The history of revision change for the specification

Power Choke Coil VCMT136E MN54M type

Current Characteristic

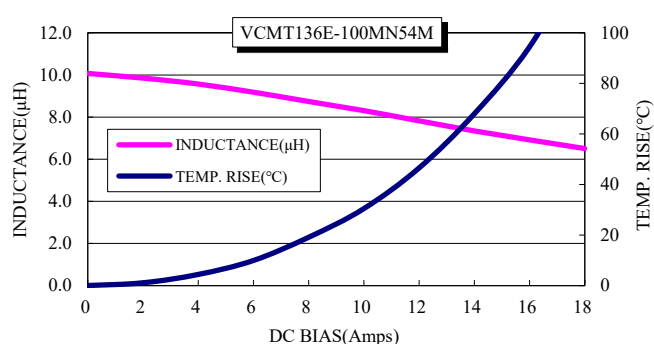
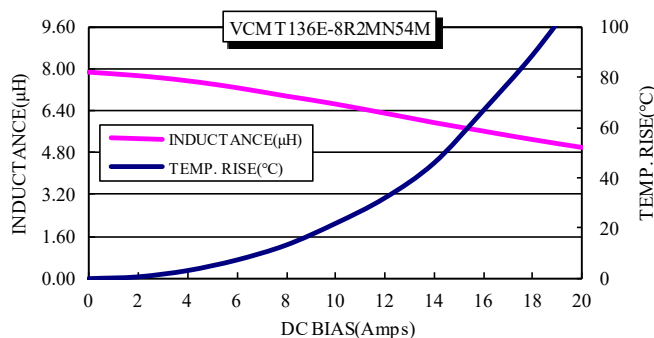
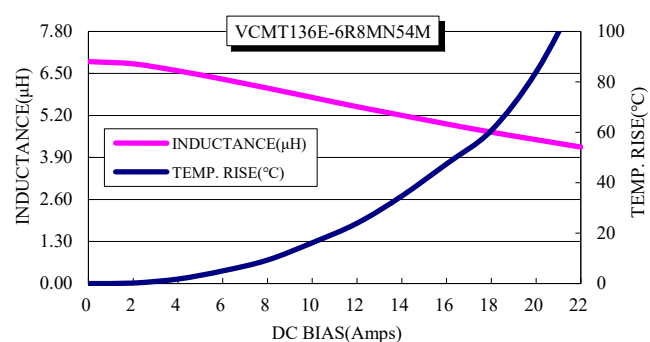
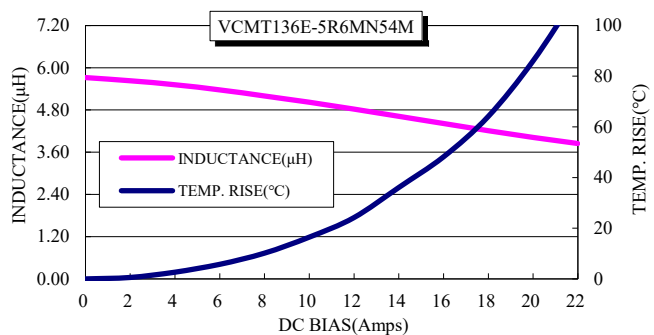
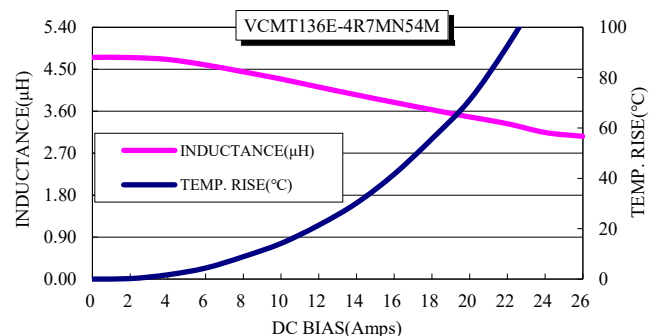
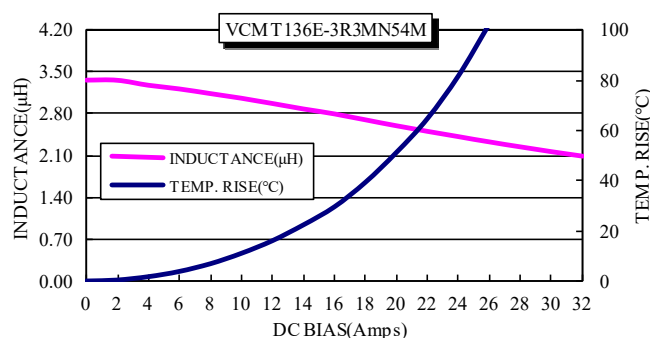
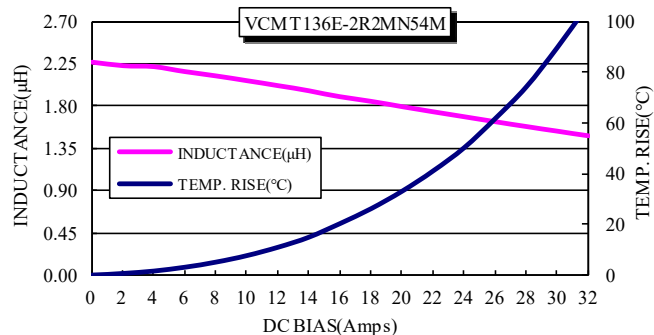
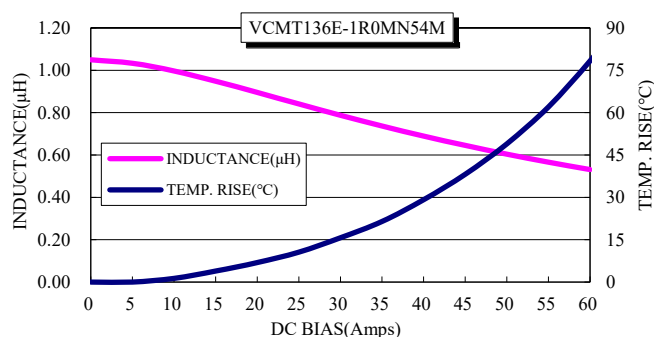
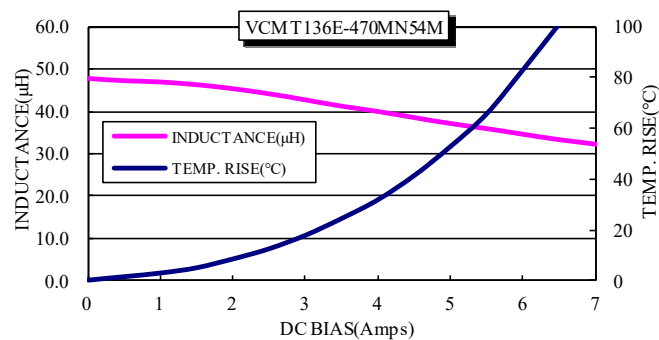
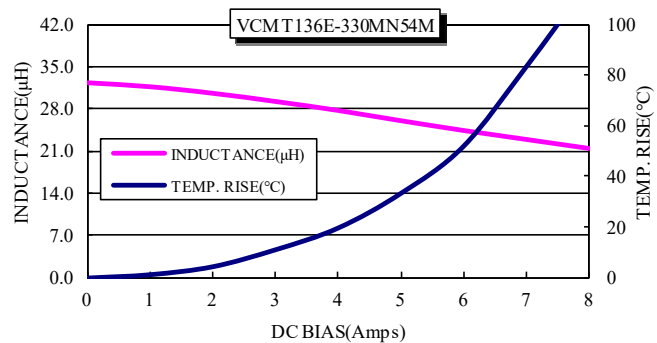
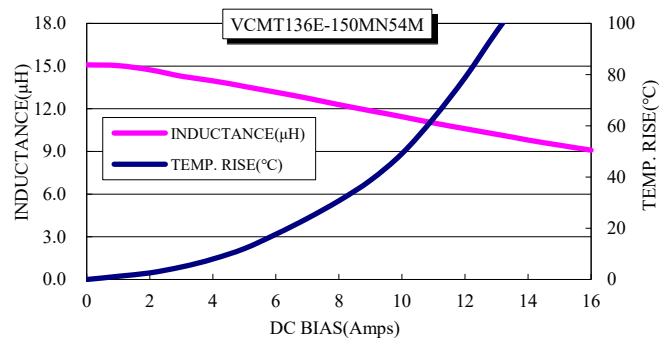
Document	REV.	Modified date	Description
CYNVC-19X-033	A0	2019.10.17	New approval
CYNVC-19X-033	A1	2019.11.13	1. Oct. -> Nov 2. Add 6R8, 8R2, 330 spec and curve 3. Remove 1R0, 220 spec and curve 4. Update 150 spec Idc(Typ./Max.): 8.5/7.7 -> 8.7/7.8
CYNVC-19X-033	A2	2020.1.13	1. Nov., 2019 -> Jan., 2020 2. Year Code: 2019 = 9 -> 2020 = 0 3. Remove frequency: (1MHz) from Features
CYNVC-19X-033	A3	2020.2.4	1. Jan., -> Feb., 2. Add 1R0 spec and curve
CYNVC-19X-033	A4	2021.2.25	1.Feb.,2020 -> Feb.,2021 2.Add 2R2, 3R3, 4R7 spec and curve
CYNVC-19X-033	A5	2021.6.15	1. Feb. -> Jun. 2.Add 5R6 spec and curve
CYNVC-19X-033	A6	2024.09.23	1. Jun., 2021 -> Sep., 2024 2. Year code 2021 = 1 -> 2024 = 4 3. Add notice 'Shielded construction' in Features 4. Reflow Soldering : 217°C -> ≥217°C
